PRELODGE MENT ADVICE

Date of Advice	3 March 2026	Time: 9am
Meeting Location	Microsoft Teams	
EDQ PRE Ref. No.	PRE-2026-FLA-4492	
EDQ Contact Officer	Rachel Ritchie	
	Rachel.Ritchie@edq.qld.gov.au

Priority Development Area (PDA)	Greater Flagstone
Proposal	PDA Development Permit for Reconfiguring a Lot – One (1) into thirty one (31) Industrial Lots, New Road, Balance Lots and PDA Development Permit for Material Change of Use for Various Commercial and Industrial Uses in accordance with a Plan of Development
Site Address	824-908 Greenbank Road, North Maclean
Real Property Description	Lot 1 on RP121663

Date of Advice	23 June 2026	Time: 11am
Meeting Location	1 William Street, Brisbane	
EDQ PRE Ref. No.	PRE-2026-FLA-4885	
EDQ Contact Officer	Rachel Ritchie, Principal Planner	
	Rachel.Ritchie@edq.qld.gov.au

Figure 1: North Maclean Context Plan

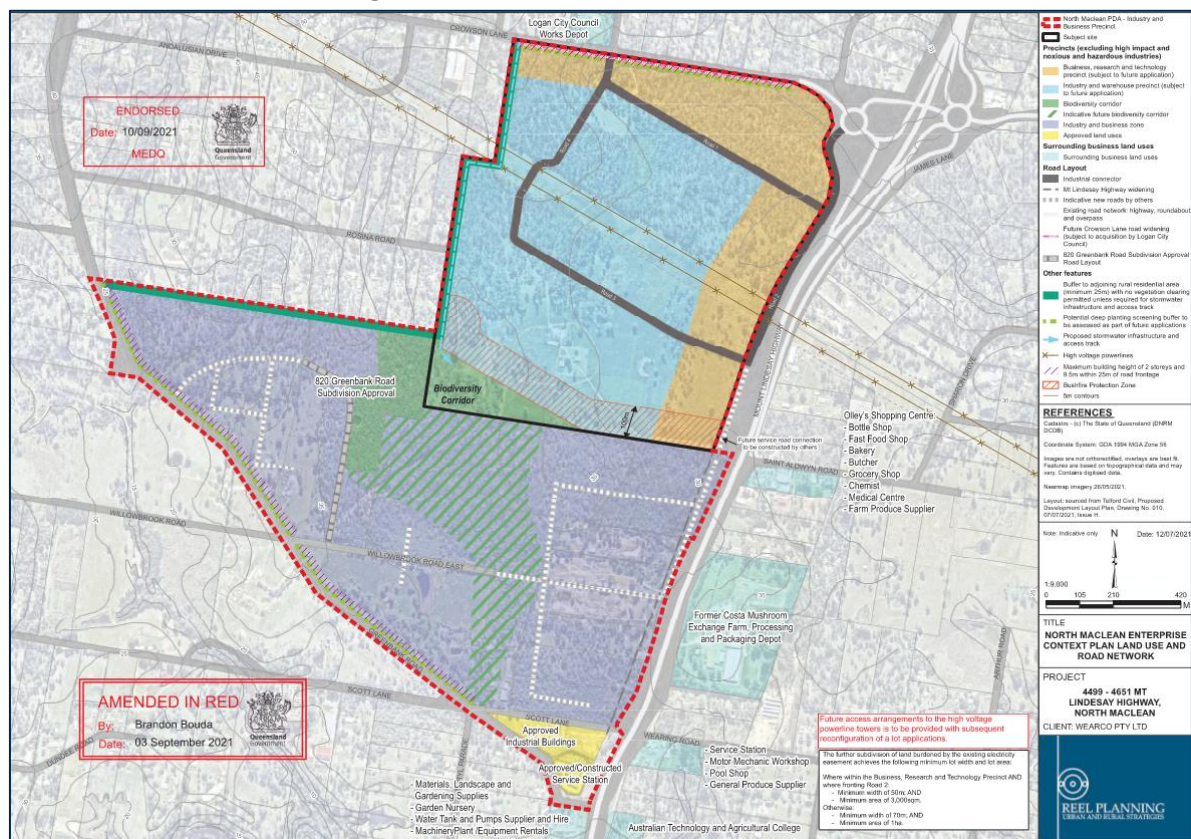
Also relevant to the proposal is the endorsed North Maclean Context Plan (Figure 1 and Figure 2), with the subject site located to the south of the context plan area. The subject site is shown on the context plan as:

- being within an Industry and Business Zone
- an indicative future biodiversity corridor overlay along the eastern part of the site
- a potential deep planning screening buffer along the site's western boundary (Greenbank Road frontage)
- a maximum building height of 2 storeys and 9.5m within 25m of the Greenbank Road frontage along the site's western boundary

Figure 3: Regulated vegetation and essential habitat mapping (Source: DAMS)

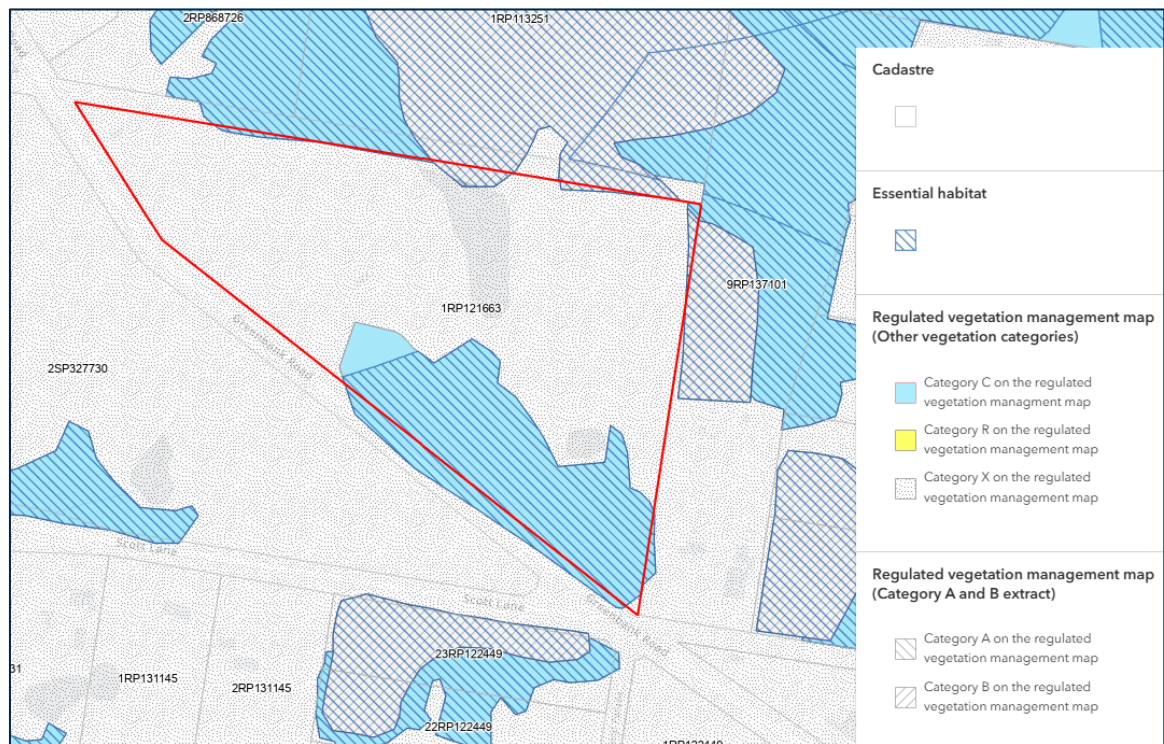
- Biodiversity
 - MSES – Wildlife habitat (endangered or vulnerable, special least concern animal, koala habitat areas – core)
 - MSES – Regulated vegetation (category B, category c, essential habitat, wetland)
- Natural hazards, risk and resilience - *Flood hazard area – local government flood mapping area and bushfire prone area*
